Review Revit module Heating and Cooling Loads

I think I found a few errors in the module Heating and Cooling Loads. I would like to get to know if these things are real errors, I am mistaken or that they are on purpose. Second I would like Autodesk to add a few extra options to the module Heating and Cooling Loads and I am curious if that's possible on the short term.

Figure 1: Building Categories at Building Construction

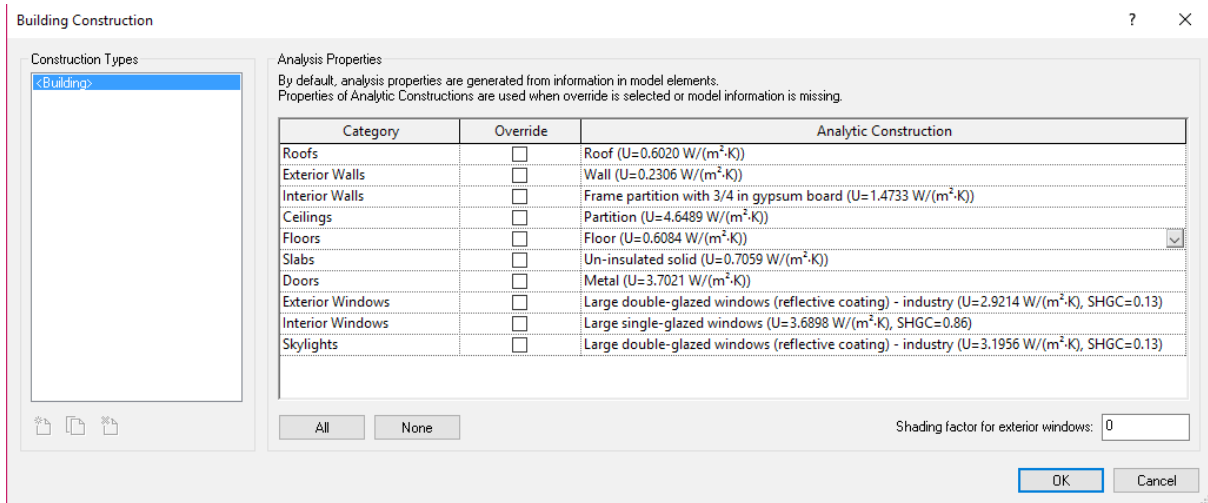
Problem:

The categories from 'Heating Components' do not match the categories at 'Building Construction':

Why aren't the categories matching or are they like this?

Figure 4: error when the Air Temperature is lower than Heating Set Point

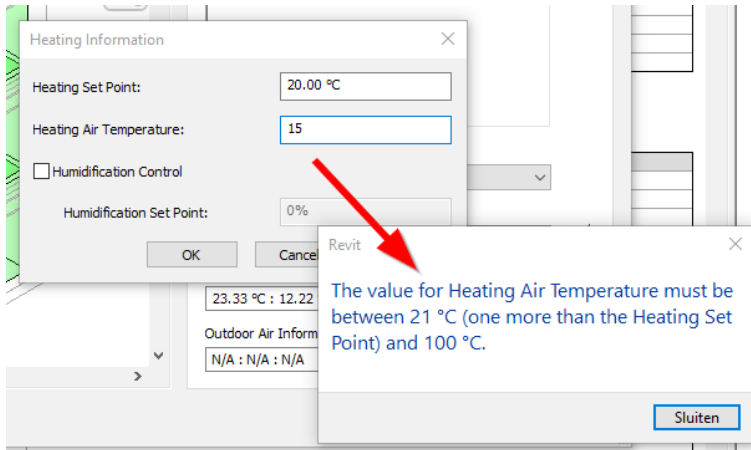
Problem:

It is not possible to calculate the heat loss to ventilation ($\Delta T = \text{room temperature} - \text{air temperature}$) with Heating and Cooling Loads:

When the air temperature for Cooling Load is given in this error (of course) does not occur.

Can this option (Heat Loss to Air) be added to the module Heating and Cooling Loads?

Calculate heat loss to ventilation in schedule and add it manually to total heat loss.
